UNITED STATES PATENT AND TRADEMARK OFFICE

10/796,704

Toru Takayama

Office Action Summary	Application No.	Applicant(s)	
	10/796,704	TAKAYAMA, TORU	
	Examiner	Art Unit	
	Delma R. Flores Ruiz	2828

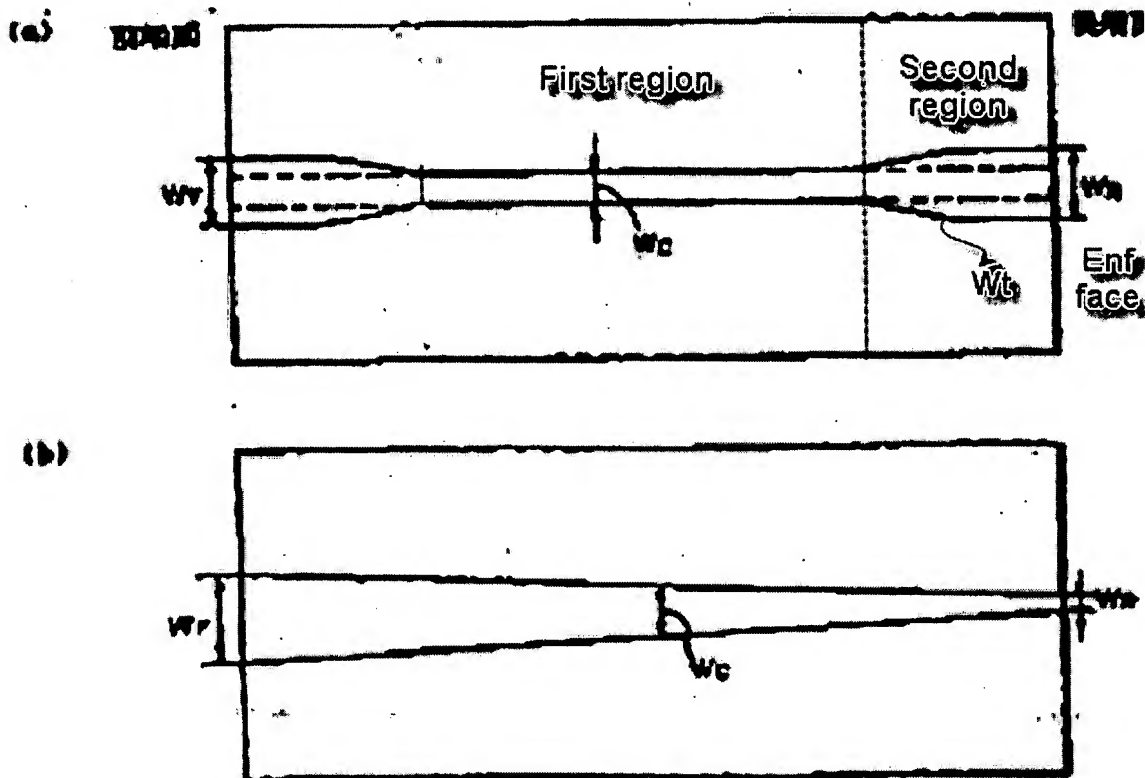
Regarding claim 16, Shimoyama shown in Figures 1 – 3, discloses a semiconductor laser device formed on a tilted substrate (see Fig. 1A Character 101) composed of a compound semiconductor, comprising an active layer (see Fig. 1A Character 106) and two cladding layers (see Fig. 1A and 1B Characters 102 and 111) interposing the active layer therebetween, wherein one of the cladding layers (see Fig. 1B, Character 111, and Paragraph [0048-0049]) forms a mesa-shaped (see Fig. 1B, Character 110, Paragraphs [0013, 0026-0027 and 0055-0056], the reference call “stripe-like opening”) the ridge includes a first region (see Fig. 3a, Character W_C) where a width of a bottom portion of the ridge is substantially constant, and a second region

(See Fig. 3a, Characters W_t) where the width of the bottom portion of the ridge is varied continuously, and the second region (see Fig. 3a, Characters W_t) is placed between the first region (see Fig. 3a, Character W_c) and an end face (see Fig. 3a, Character W_R) in an optical path, and end face in an optical path, and a length of the first region is 10% to 50% with respect to a resonator length (see Paragraph [0058-0059]).

Regarding claim 22, Shimoyama shown in Figures 1 – 3, discloses the second region is placed between the first region and one end face in the optical path, and between the first region and the other end face in the optical path (see Figure 3A).

Regarding claim 23, Shimoyama shown in Figures 1 – 3, discloses at a boundary between the first region and the second region, the width of the bottom portion of the ridge in the first region is substantially the same as that in the second region (see Figure 3A and 3B).

FIG. 6

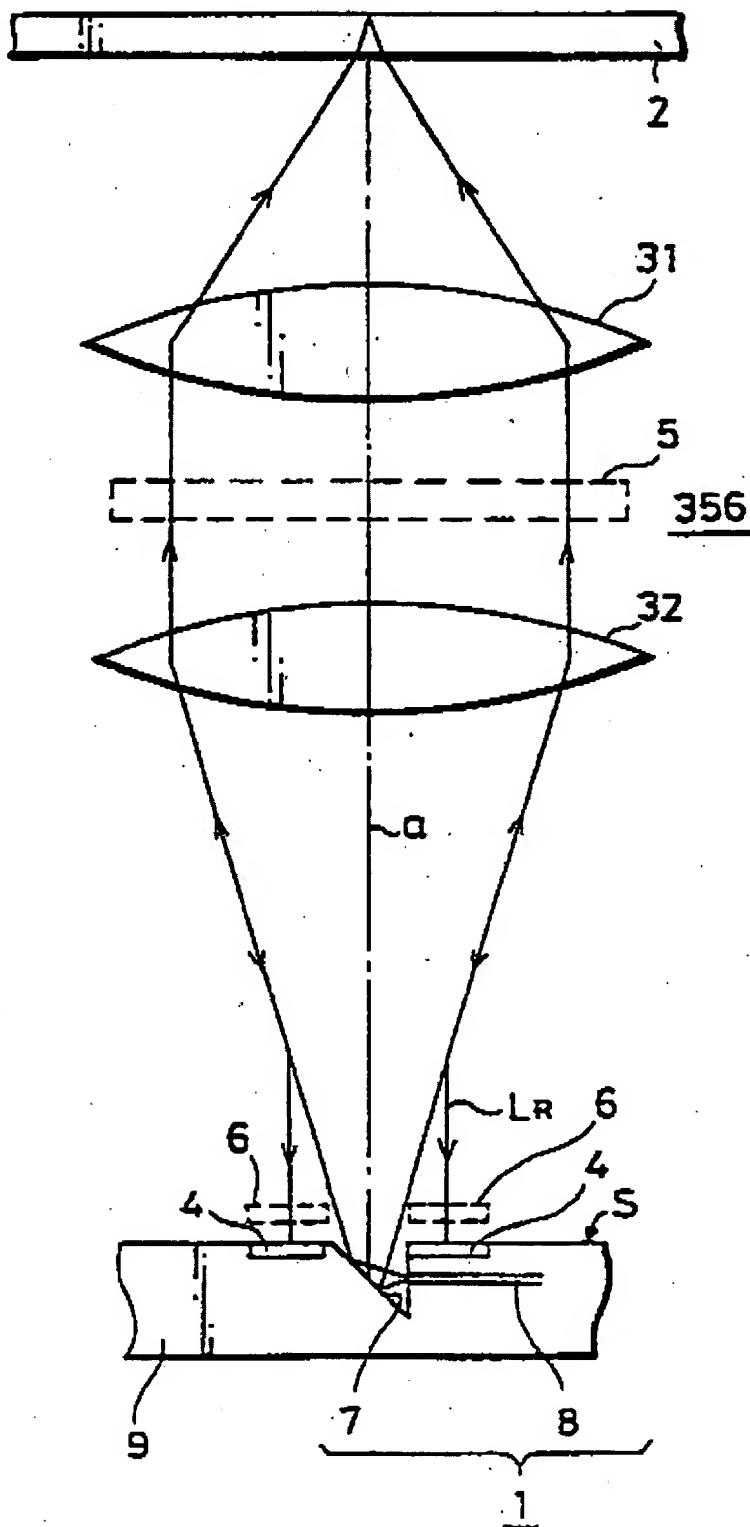
Regarding claims 24 – 28, Shimoyama Kenji discloses the claimed invention except for reflection mirror. However, it is well known in the art to apply the reflection mirror as disclosed by Doi in Figure 1. Therefore, it would have been obvious to a person having ordinary skill in the art at the time the invention was made to apply the well known reflection mirror as suggested by Doi to the semiconductor laser of Shimoyama Kenji, because it could be used to reflect a laser beam.
